## CITY OF TONTITOWN PLANNING OFFICE

Meeting: **September 28, 2021**  
Project: **Mathias Warehouse  
Variance Request**  
Planner: Courtney McNair, Garver

### BOARD OF ZONING ADJUSTMENTS AGENDA ITEM

### VARIANCE REQUEST

**AERIAL PHOTO 2017:**

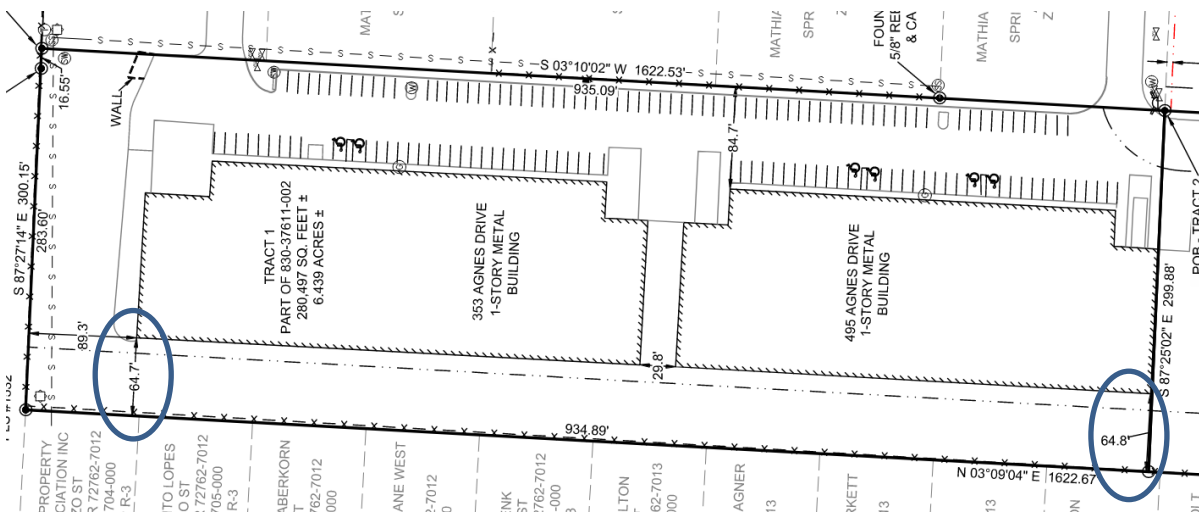
One difference between the buildings approved previously on the property to the north and the current request, is the increased number of residences that have been constructed in this adjacent subdivision. Please see below aerial photos from 2016, 2017, and 2021:

**Even though this property is surrounded by non-conforming structures, that is not sufficient reason to allow the reduction of the rear setback.**

PRELIMINARY PLAT

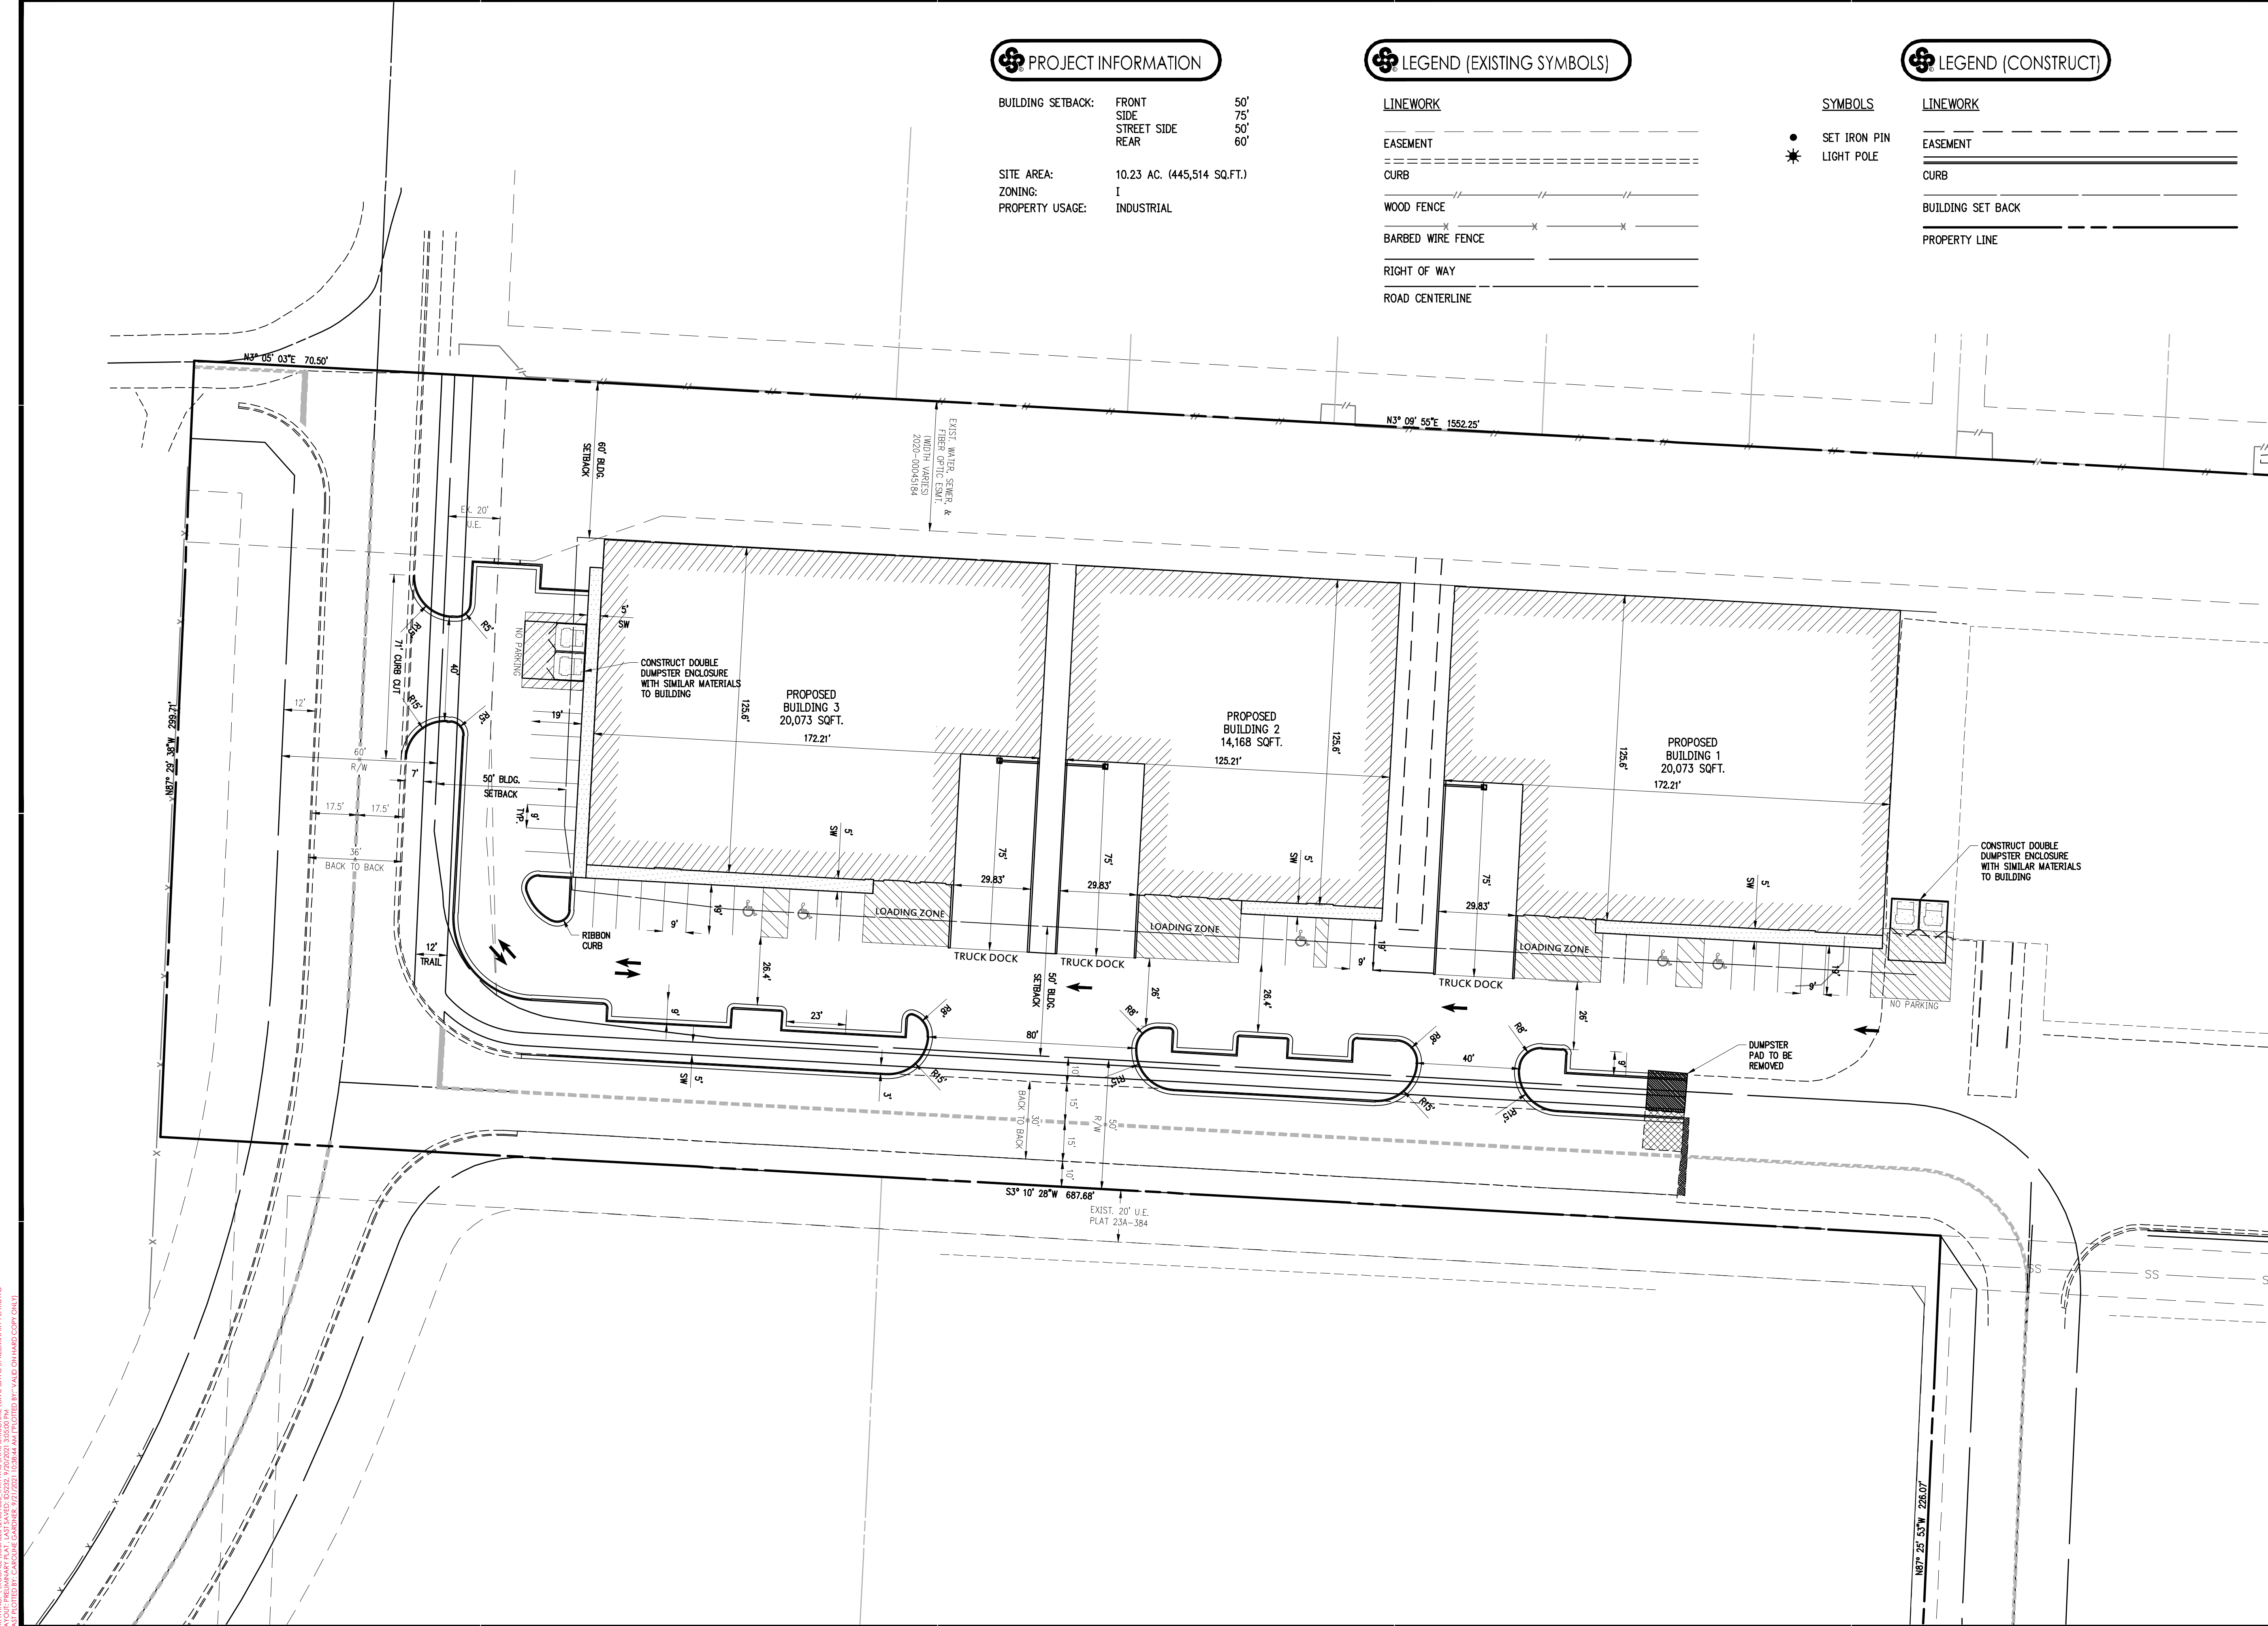
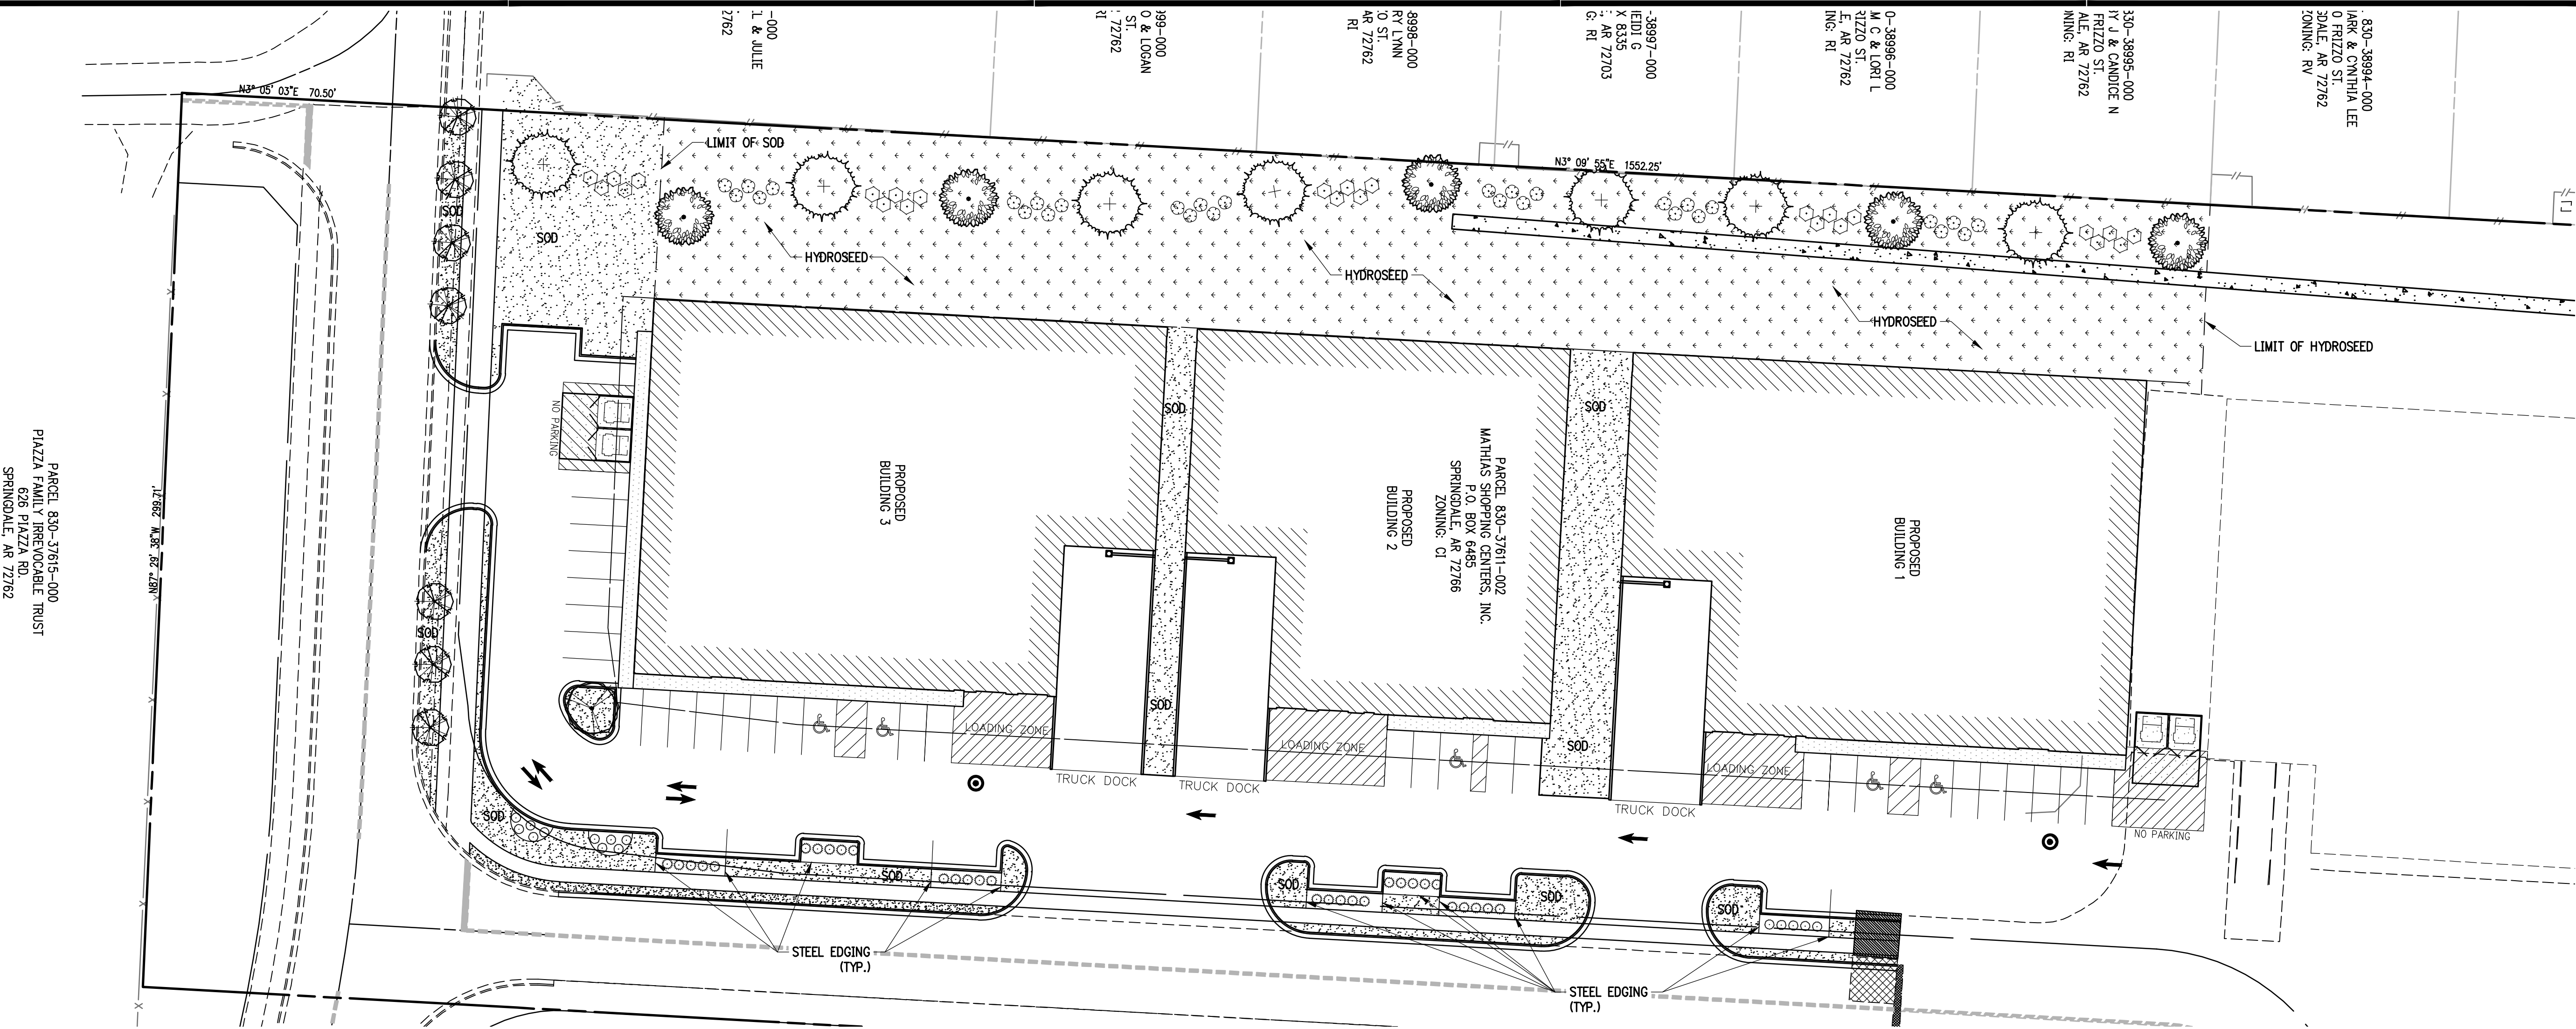
**As the Residential Compatibility Standards apply to this project, the actual request will be to reduce the Rear Setback from 150' to 60'.**

**Additionally, the structures to the north are 64.7'-64.8' from the property line, so this requested reduction would place the proposed structures even closer to residential properties. See below and attached copy of the recent lot split.**

**Staff does support reducing the rear setback by 50% to 75' with additional buffering, screening, and building articulation as listed in the following recommended conditions.**

If the Planning Commission approves the request to reduce the rear setback from 150' to 75' (or from 150' to 60' per the applicant's original request), staff recommends the following conditions:

**2 WEST ELEVATION**  
1/8" = 1'-0"

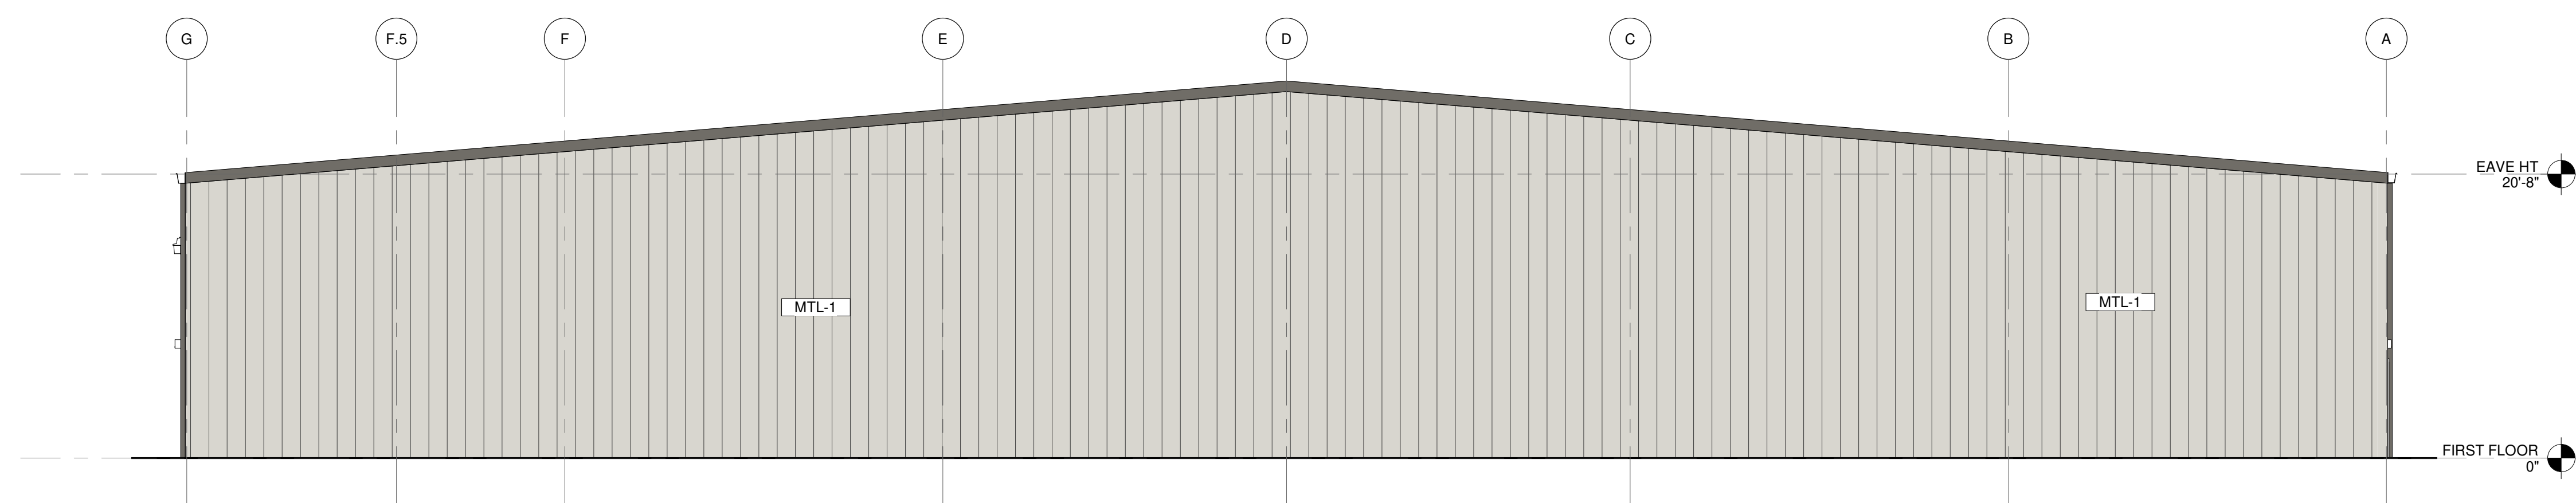
- At the City's request, the applicant dedicated ROW for Mathias Ave. This was not due to an action by the applicant when regarding the front setback variance request.
- The building design should be considered when reviewing the request for the rear setback variance. Preliminary rear elevations do not show any that any consideration for design adjacent to residential has been considered.

3. Architectural plans shall be submitted as part of the Large-Scale Development (as already required by LSD code) and shall provide articulation and use other methods to reduce the visual bulk of the buildings on the rear (west) side. Elevations shall provide enough detail so that Planning Staff is able to review the proposed impact. The Architectural Plans shall be approved by the Planning Commission.
